File SPR-1996-072

Name: 709 Horizon Drive – Alpine Bank – Site Plan Review

FILE: #SPR-96-072
DATE: April 15, 1996
STAFF: Michael Drollinger
REQUEST: Site Plan Review - Alpine Bank
LOCATION: 709 Horizon Drive
ZONING: HO (Highway-Oriented)

STANDARD ACCESSIBLE PARKING STALL DETAIL

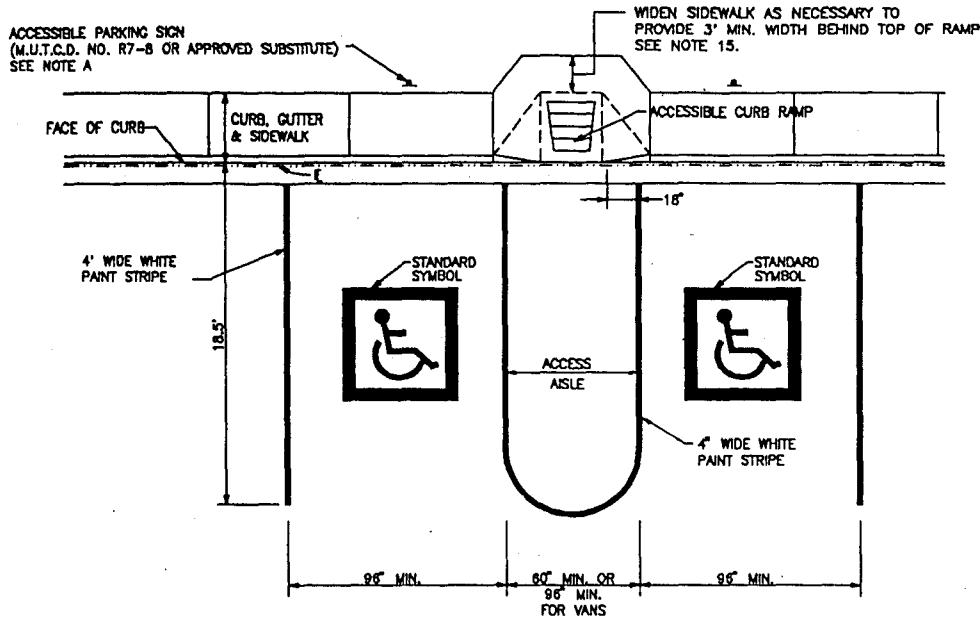
1. Please provide details as to how the required parking was calculated.
2. Remove "City Clerk and Recorder" signature block; not required.
3. A detail of the bicycle rack is required. At a minimum, the rack must be designed to accommodate three bicycles to meet Code requirements. A sample bicycle rack detail is provided for your use if desired.
4. Please clearly indicate limits of construction, particularly on the south side of the project site.
5. The row of parking stalls adjacent to the north side of the building contains 12 parking spaces, not 10 as indicated on the plans; please correct.
6. A trash dumpster enclosure detail is required.
7. Please include detail of handicapped parking stalls on plan (Accessible Parking Stall Detail attached).

7. HANDICAPPED PARKING SPACE - See Sheet A-1A.

DRAIN PIPE OUTLET DETAIL
 A-1A 1/2" = 1'-0"

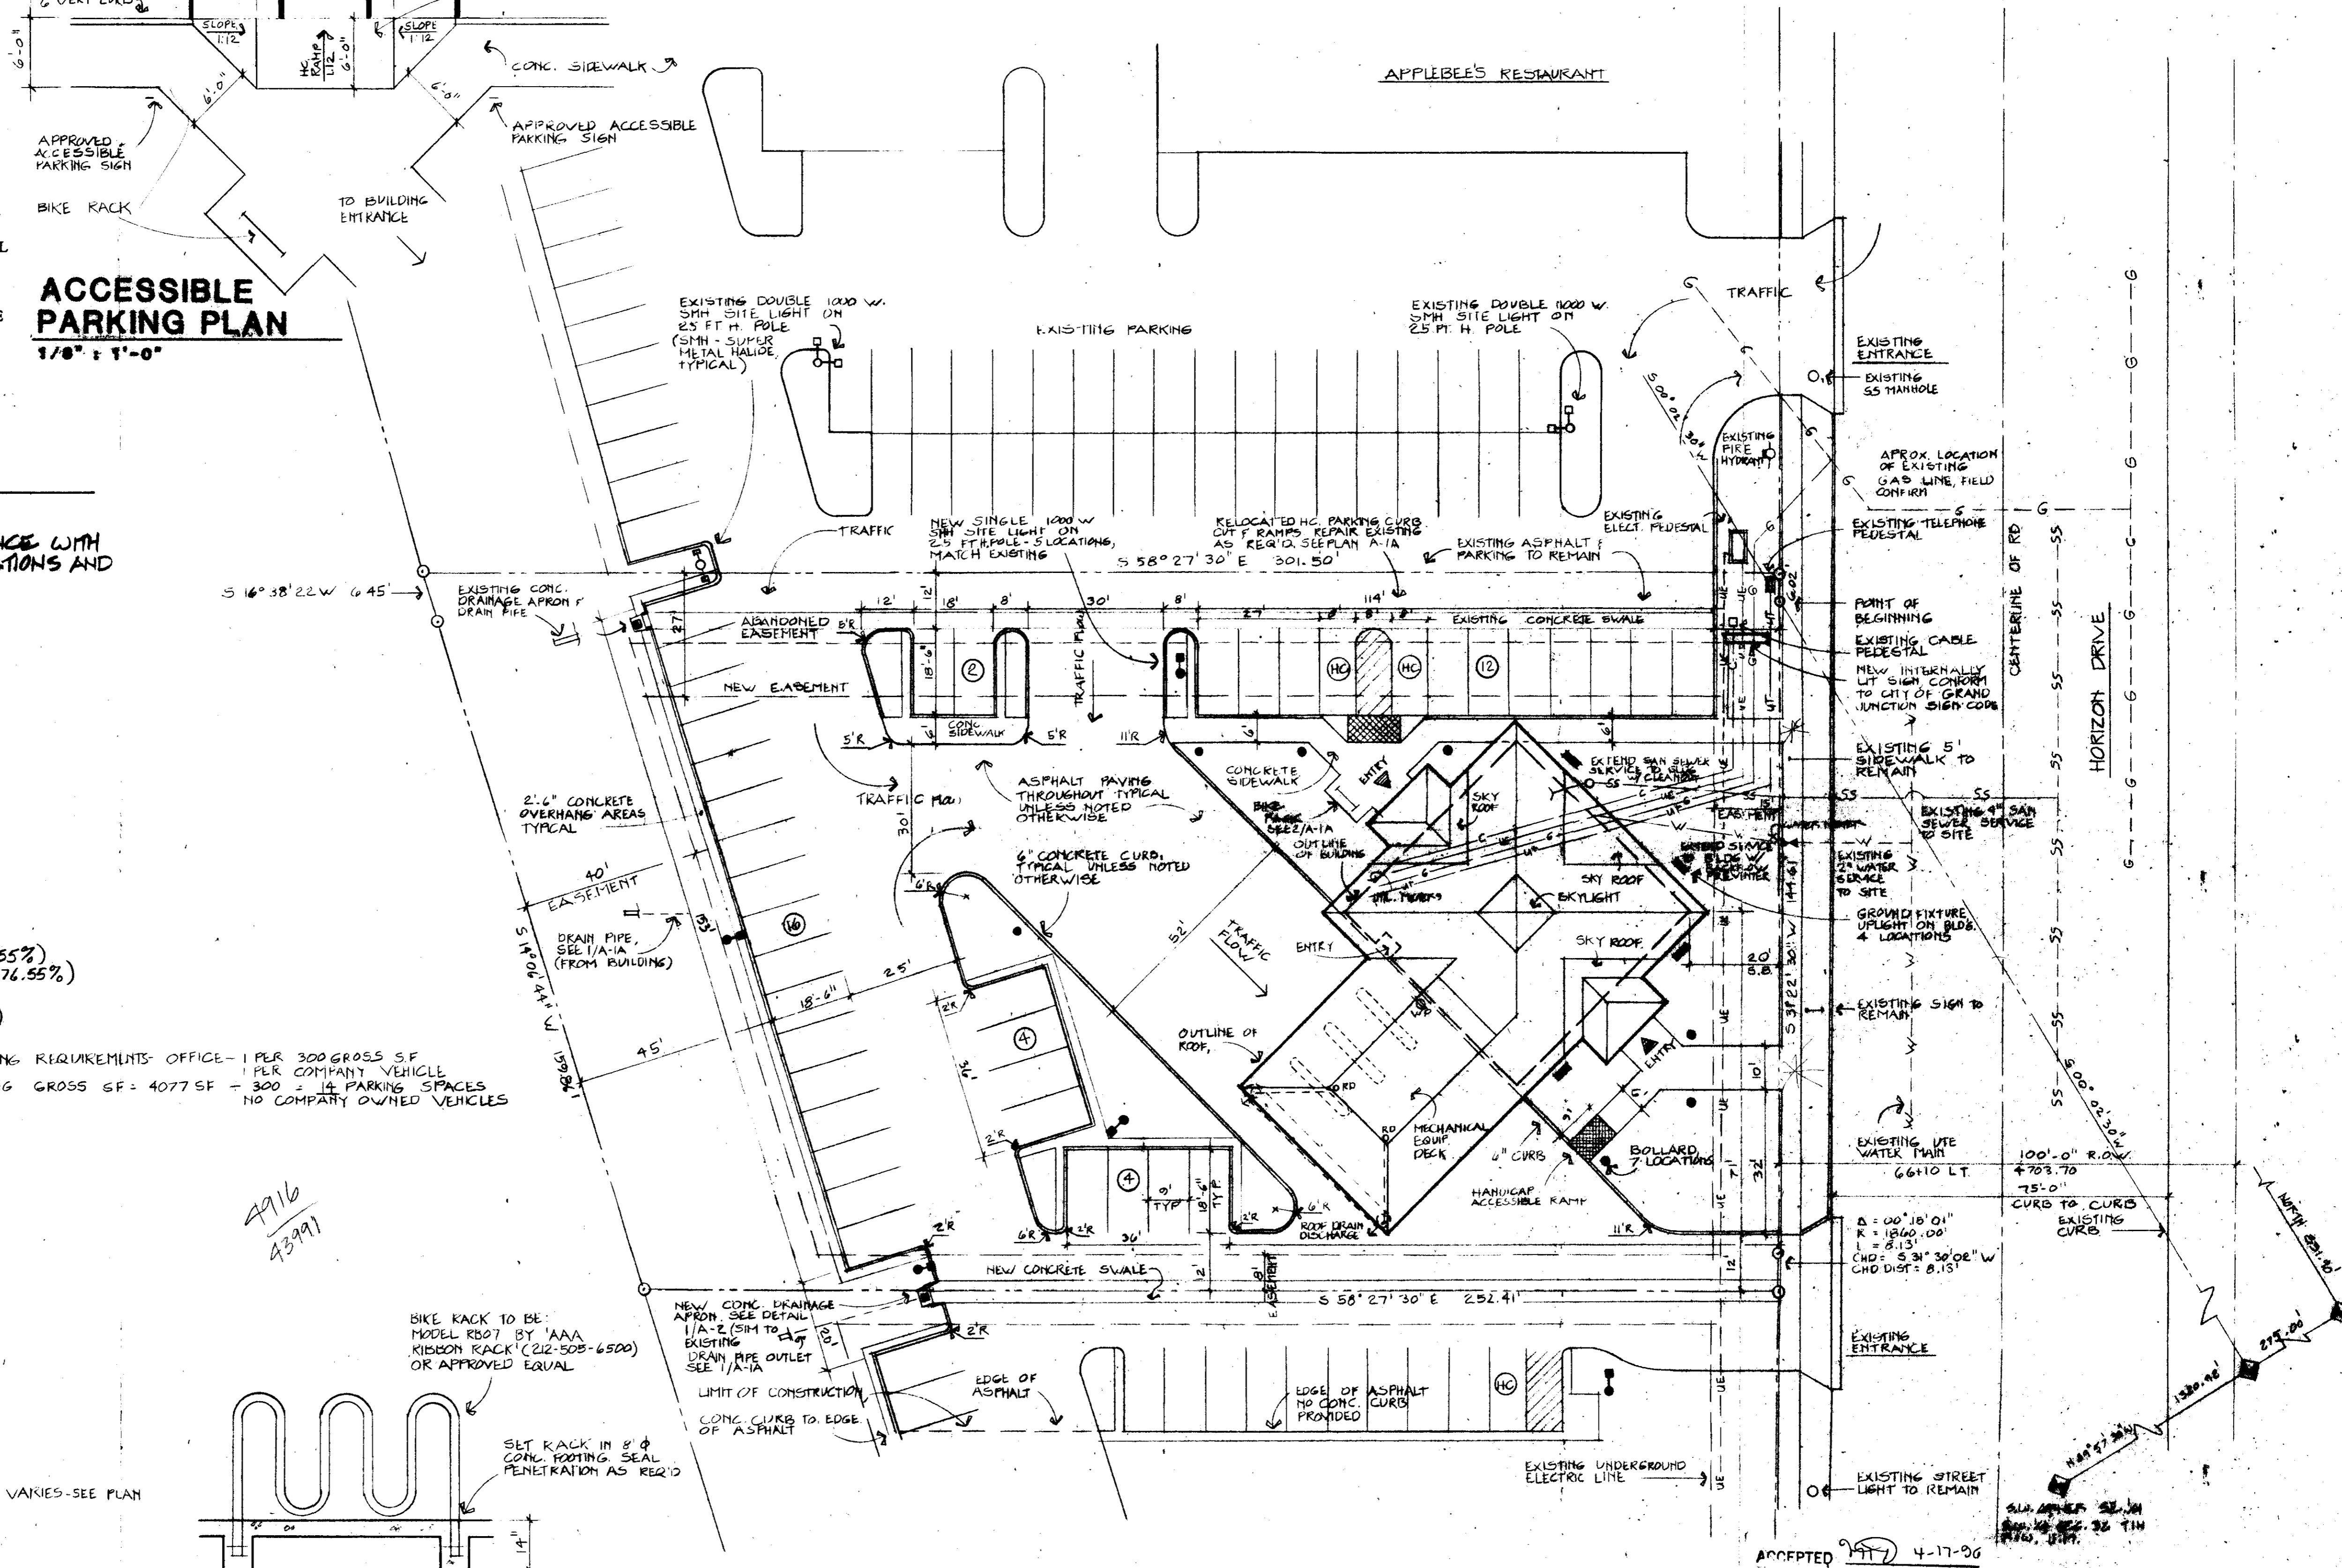
1. Drainage Fee - \$3,222.36.
2. Transportation Capacity Payment - \$10,955.82.
3. Please provide a detail for the outlet to the Horizon Channel showing the size, length, type of pipe and erosion control at the outlet.
4. Water service is Ute Water, not the City of Grand Junction.

Drainage Outlet Detail - See Sheet A-1A.

LANDSCAPE PLAN

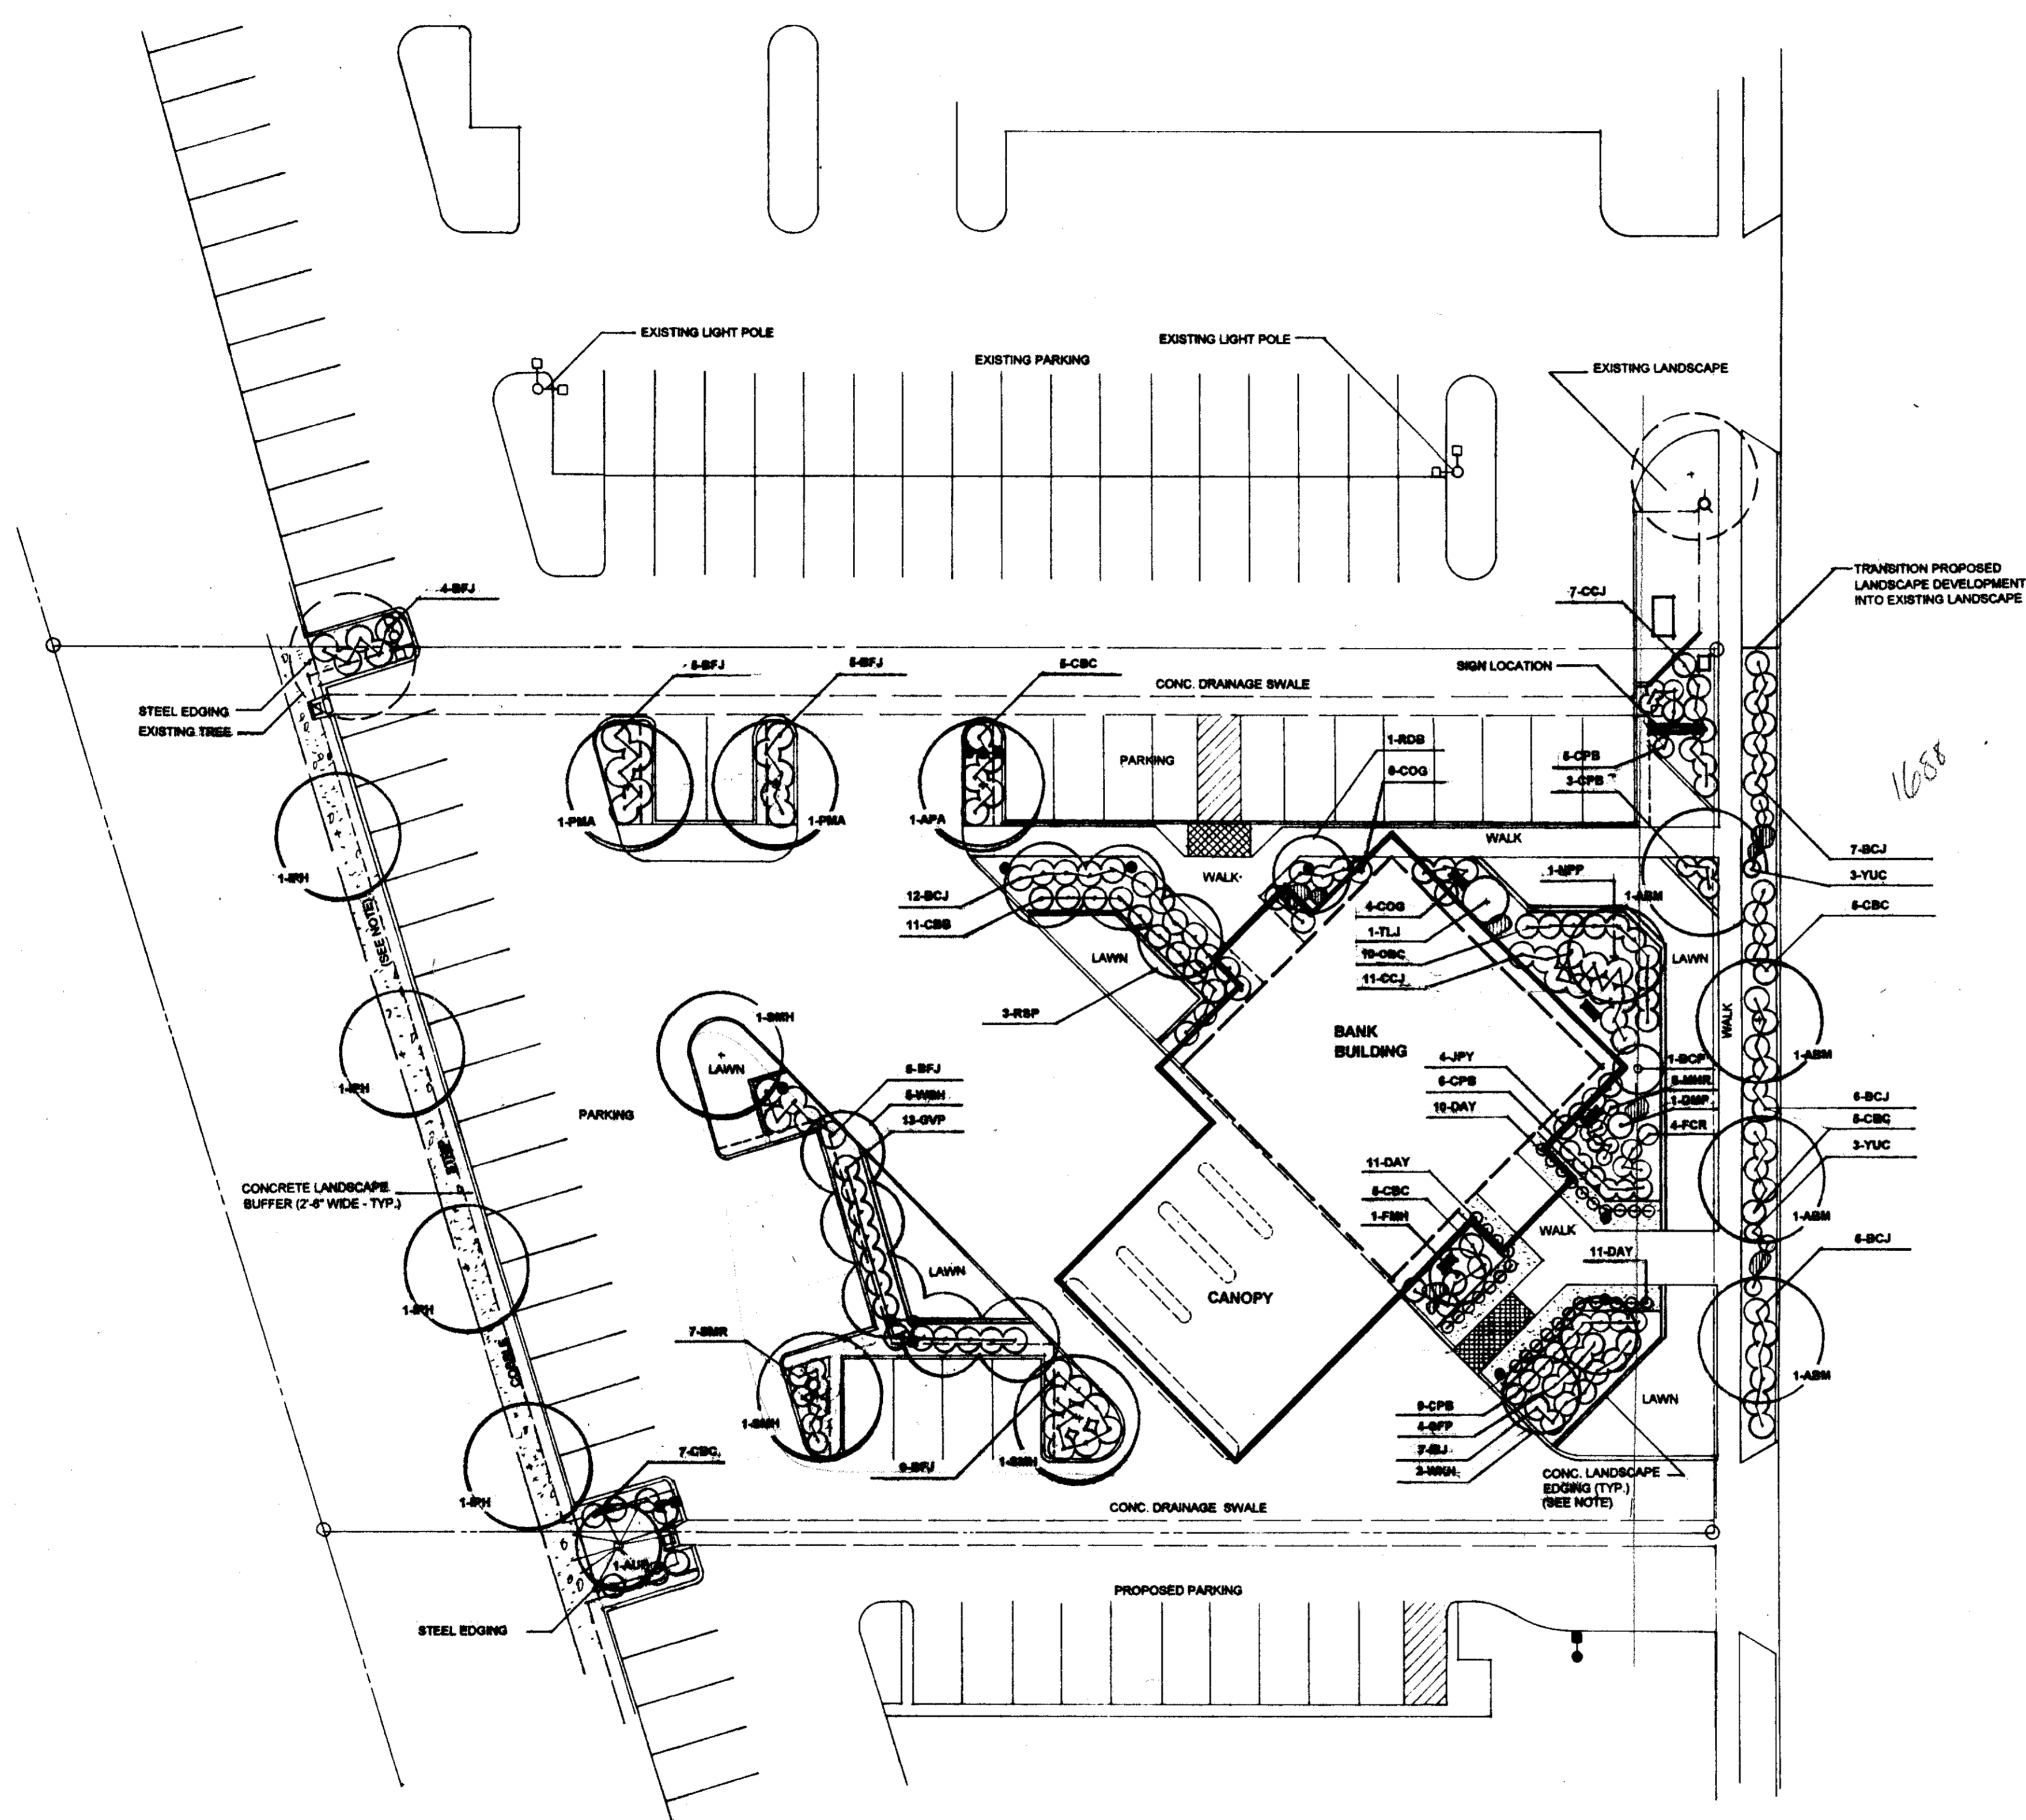
1. The standards of Section 5-5-1F2c(2) regarding the protection of landscape areas from vehicular encroachment have not been adequately addressed. Please see the attached detail from the Applebee's project which illustrates an acceptable design. Both the Landscape Plan and Site Plan must be modified to meet the Code requirement.

11. REVISED LANDSCAPE PLAN

Under separate cover to planning department 4/17/96.
